Reactor Oversight Process Task Force FAQ Log
June 15, 2017

FAQ Log June 2017

FAQ 17-01
Grand Gulf June 2016 Power Change (Draft Response)

FAQ 17-02 (Draft Response)
Palo Verde Unit 3 Scram

Figure 1: Reactor Power during the Event

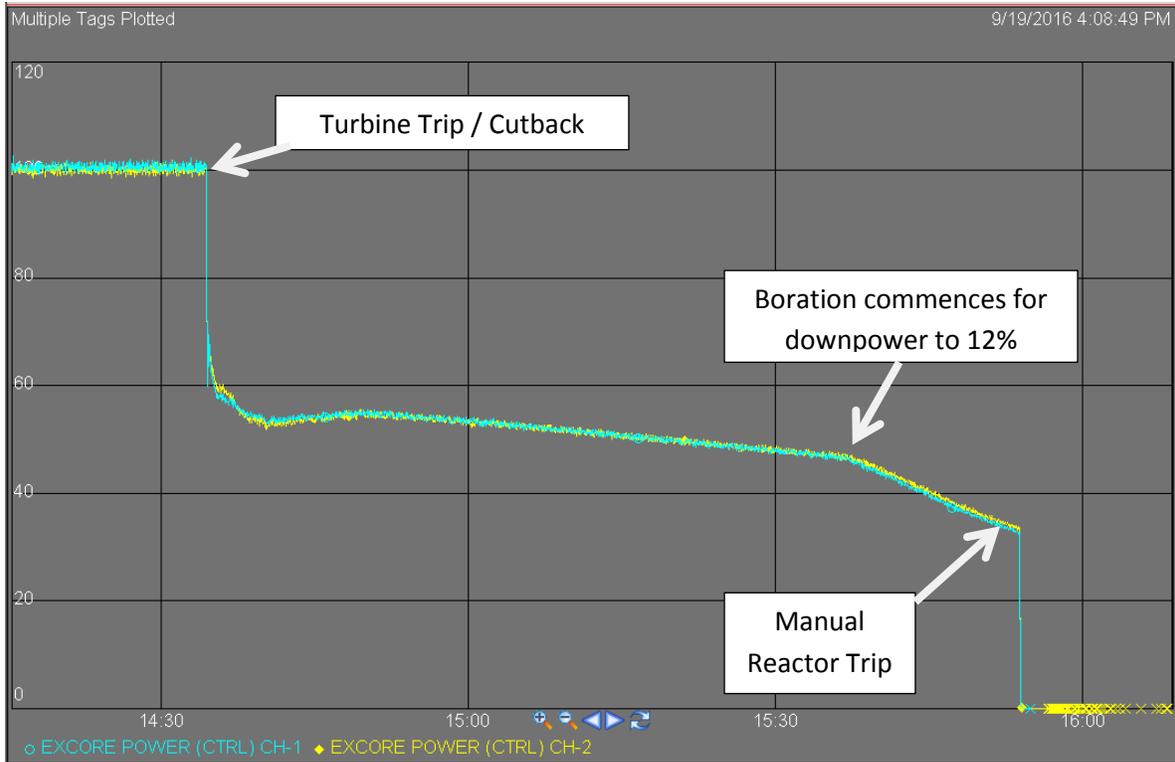
Does an unplanned power change caused by a main turbine trip that ends in an elective manual scram and is counted as an unplanned scram also need to be counted as an unplanned power change?

The resident inspector proposed that the main turbine trip event should be counted under both unplanned scram and unplanned power change performance indicators since the cause of the manual scram was discretionary and therefore different than the malfunction that caused the turbine trip-initiated unplanned power change.

On September 19, 2016, the PVNGS Unit 3 main turbine tripped at 1434 with the unit operating at 100% power. A reactor power cutback occurred automatically, as designed. The control room staff began a power reduction to 12% using abnormal operating procedure 40AO-9ZZ08, “Load Rejection.” Subsequently, based on an assessment of need for troubleshooting and repairs, potential reactivity management challenges at the end of core life, and the uncertainty of cause which might delay the return to full power, the control room staff and plant management made a decision to complete a plant shutdown and place the plant in Mode 3 by tripping the reactor using step 3.24 of 40AO-9ZZ08 from approximately 34% power at 1554 to facilitate repairs. No additional, unexpected plant conditions were occurring that would require a plant shutdown other than the loss of the main turbine. Refer to the Figure 1 for a graphical display of the power changes during the event.

This event should count as one unplanned scram and no unplanned power changes. No change to NEI 99-02 is required as a result of this FAQ.
